DEVIATION REQUEST AND DECISION FORM

Project Name: Urban Collection at Palmer Village

A deviation from the standards of or in Section <u>2.3.2 – Design Standards by Functional Classication, Table 2-7 – ADT</u> of the Engineering Criteria Manual (ECM) is requested.		
Identify the specific ECM standard which a deviation is requested:		
ADT threshold for the Local (Low Level) classification is 300.		
State the reason for the requested deviation:		
The ADT for each parcel (west and east) is anticipated to be 395 and 337, respectively. See Preliminary Plan in Attachment #2 for layout of the development. The development will utilize alleys (private) for accesses to each of the units. The low anticipated traffic demand for the neighborhood better aligns with the Local (Low Level) roadway classification.		
Explain the proposed alternative and compare to the ECM standards (May provide applicable regional or national standards used as basis):		
The roadways function as a cul-de-sac to the extent that there is only one way in and out of the developments, and the roadway (private) will function more in line with a Local (Low Volume) roadway than the Local roadway with higher volumes and incre

SHEET **3** OF **10** JOB NO. **25149.01**

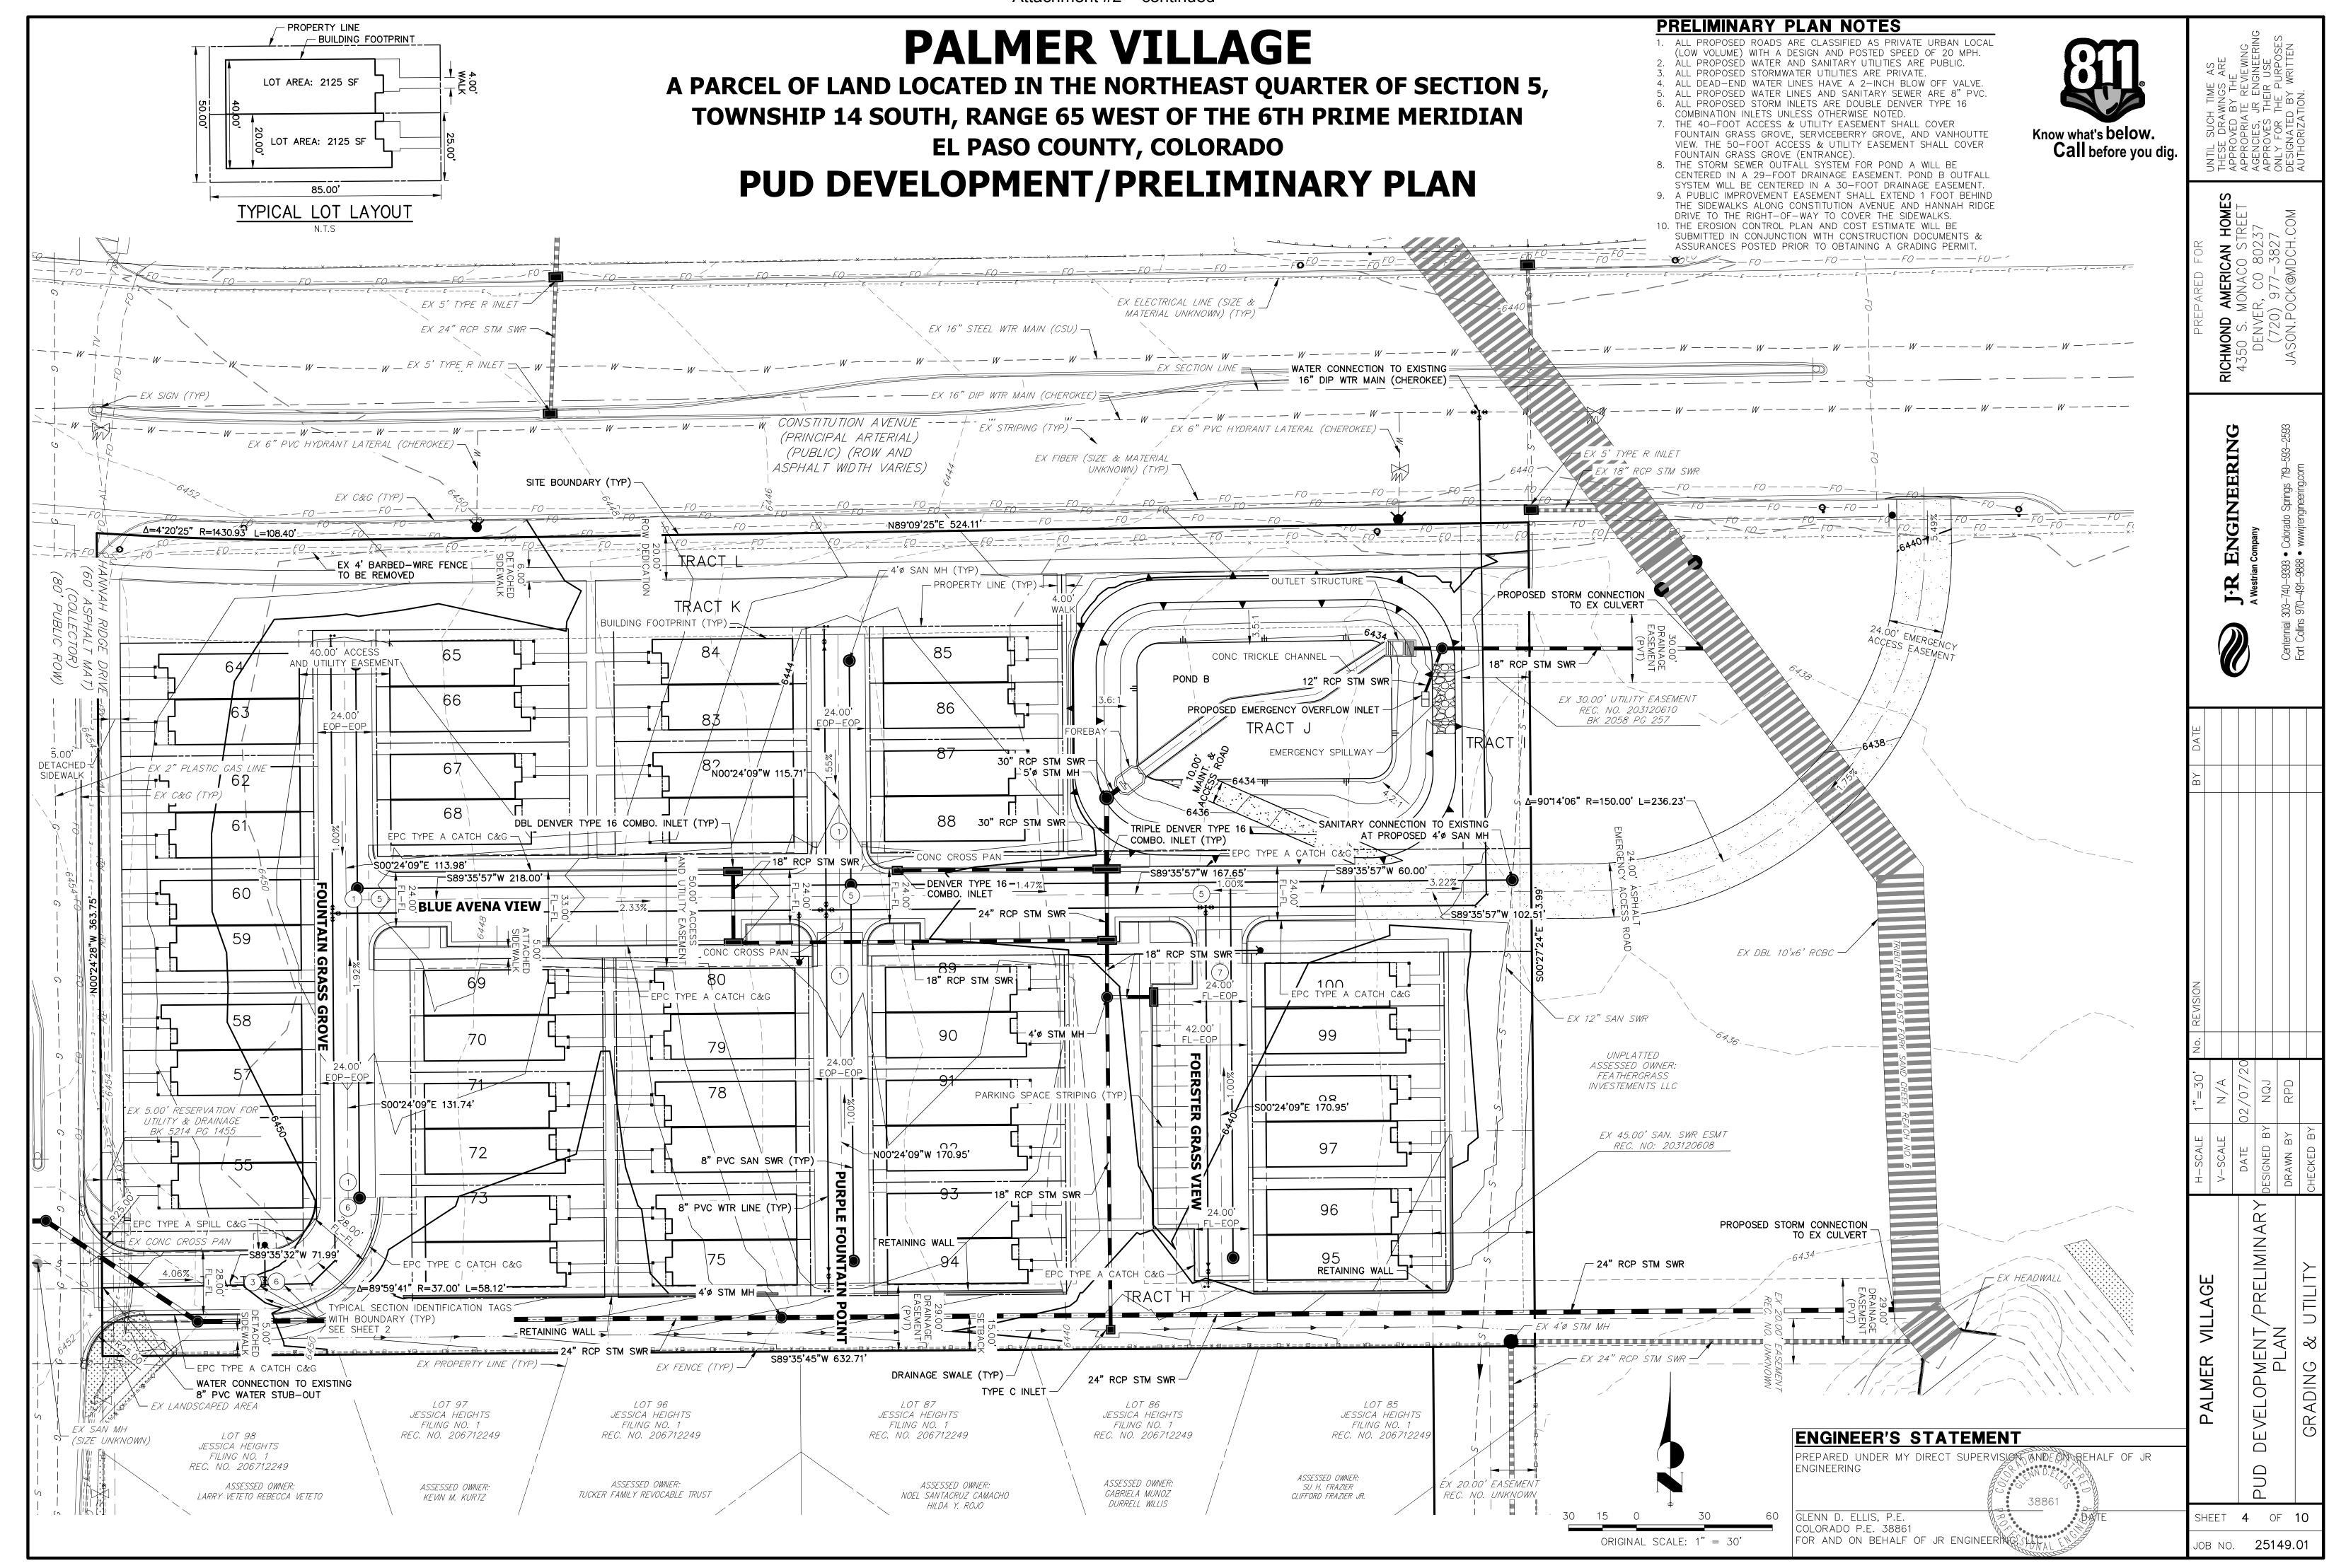
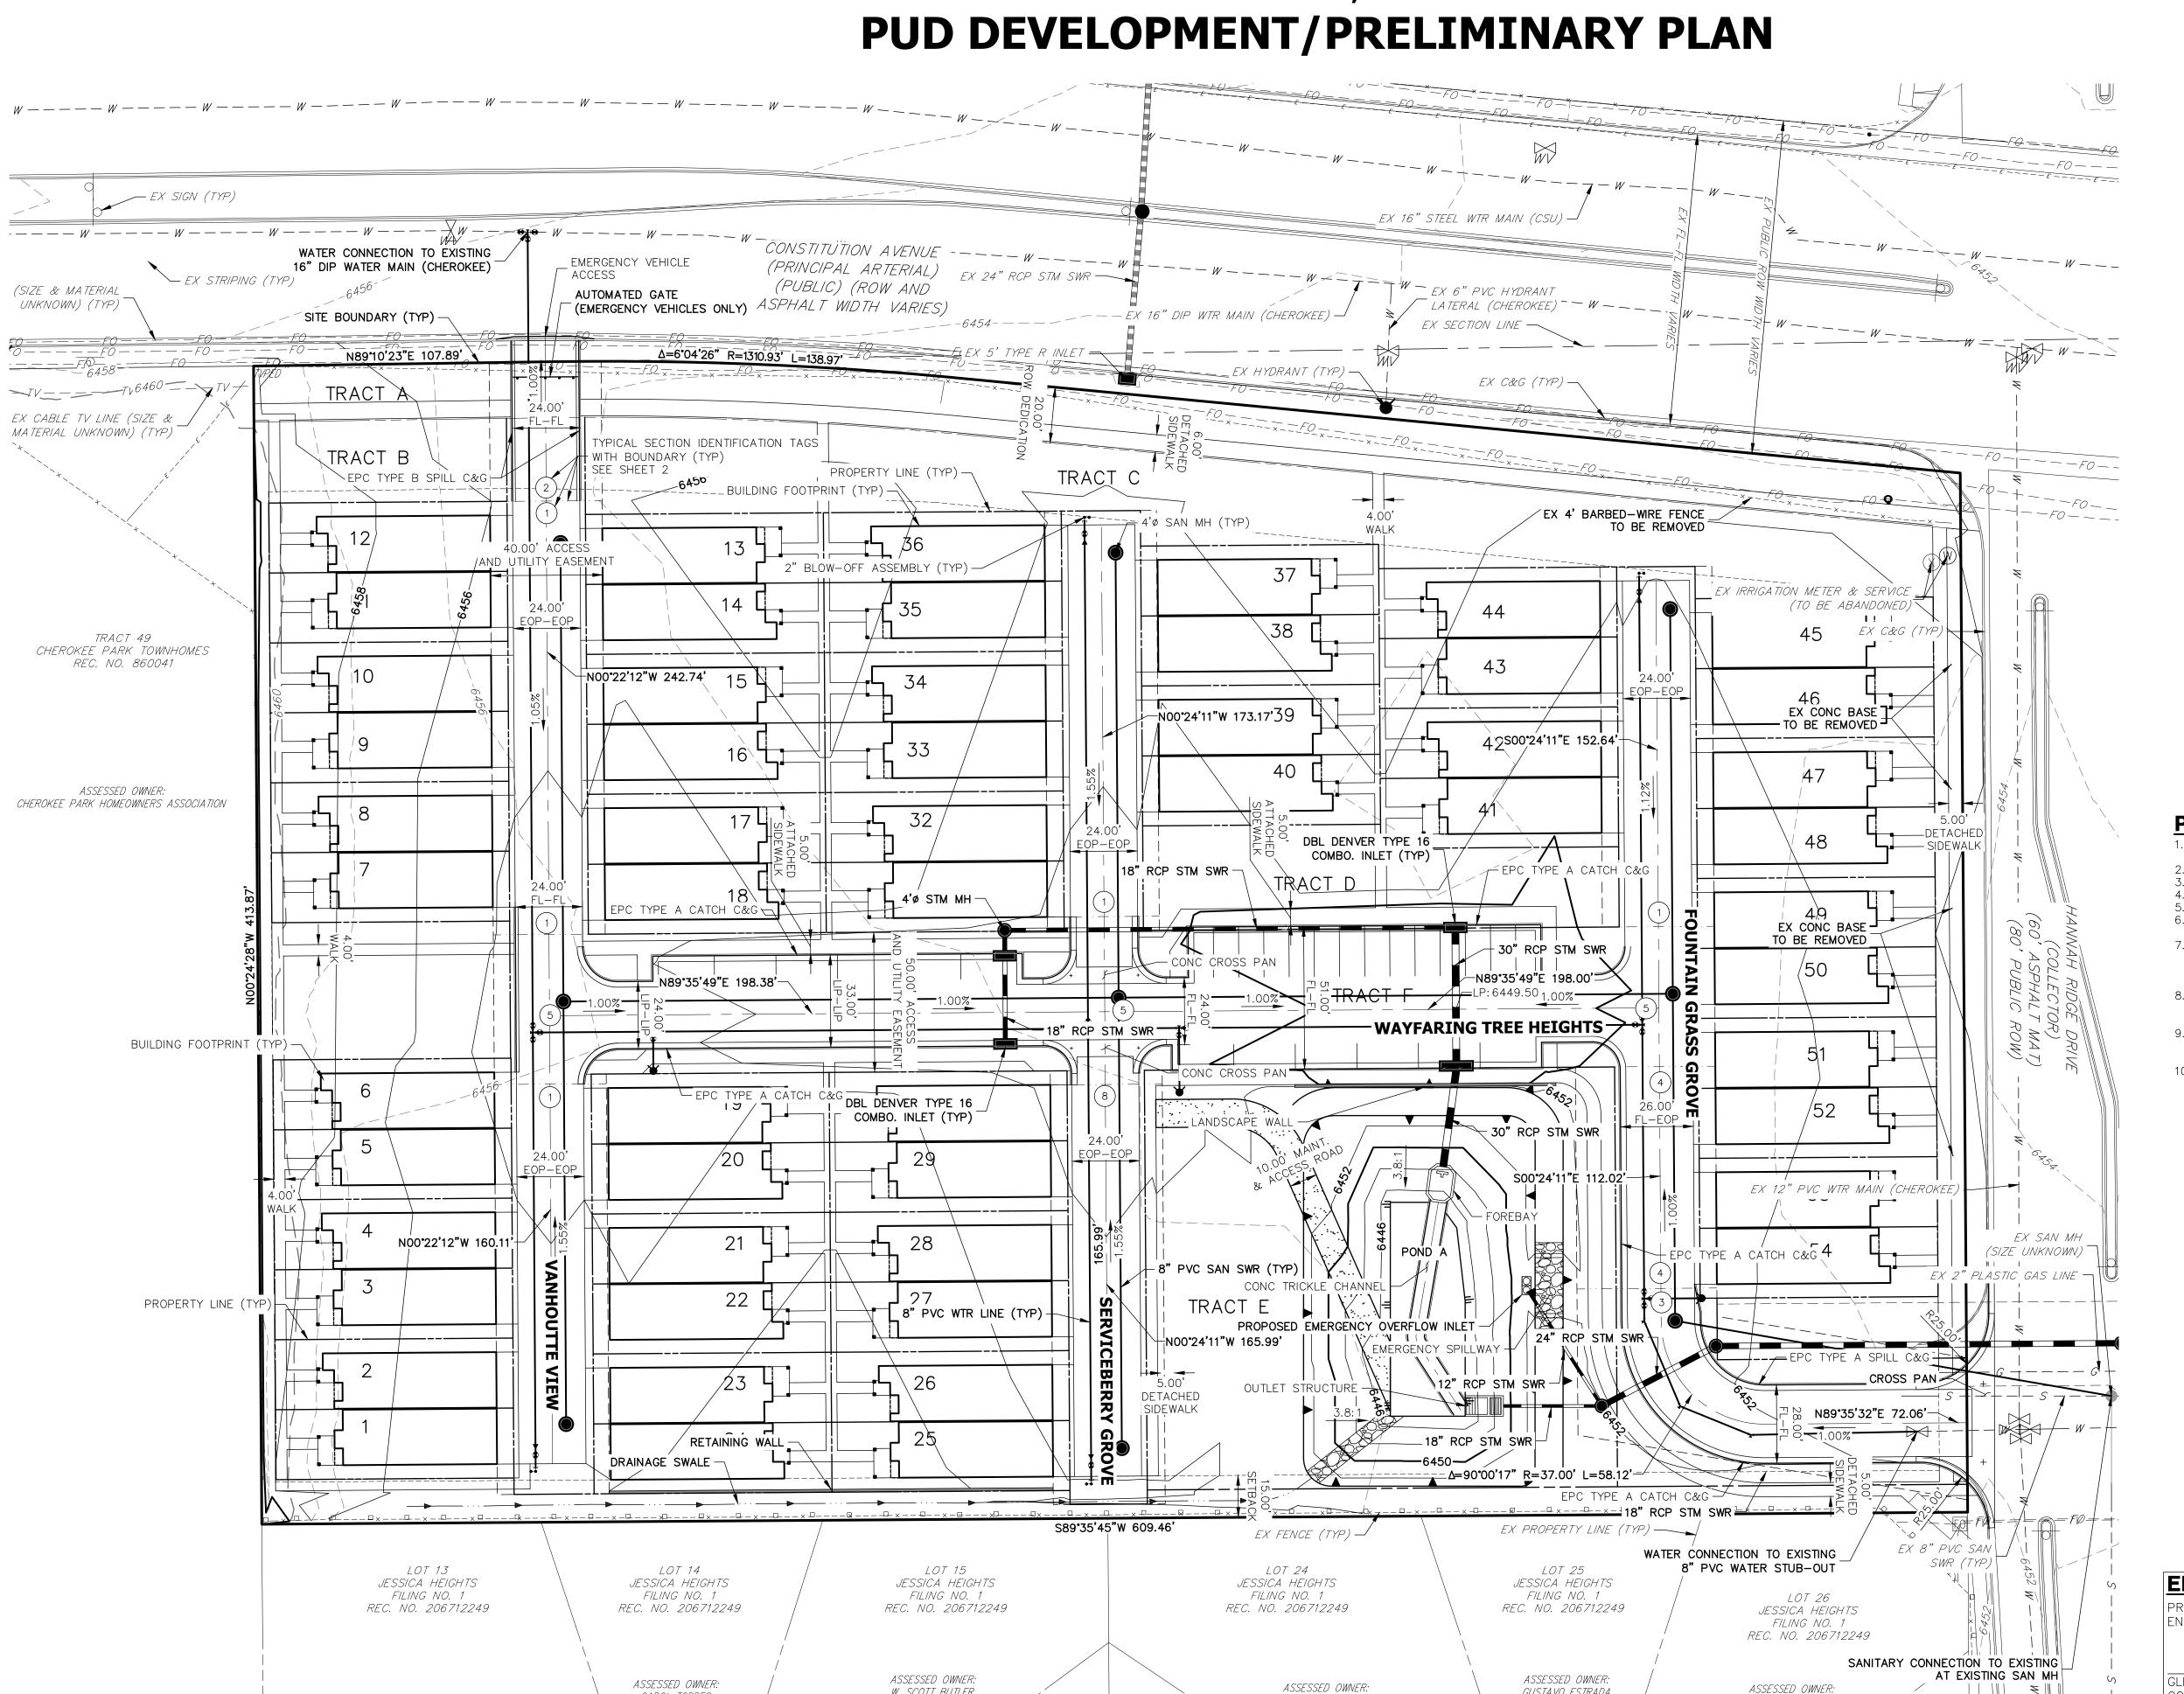
The revised design standards will not have an adverse affect on safety or operations. The anticipated volume of traffic within the development will only exceed the 300 ADT at the entrance, with reduced volumes farther into the development.

The deviation will not adversely affect maintenance and its associated cost.
Maintenance will not be impacted by utilizing the reduced design standards. The ADT is slightly above the maximum threshold, but this will
not impact the depth of pavement of the roadway, or other required components of the roadway (curb and gutter, cross-pans, etc.)
The deviation will not adversely affect aesthetic appearance.
The reduced standards of the roadway classification will not adversely affect the aesthetic appearance of the roadway or development. The
characteristics of the development with the alley loaded units, and narrow roadways will complement the type of housing constructed within
the development.
The deviation meets the design intent and purpose of the FCM standards.
The design standards of the Local (Low Level) roadway allow reduced criteria as a result of lesser volumes. The nature of the development
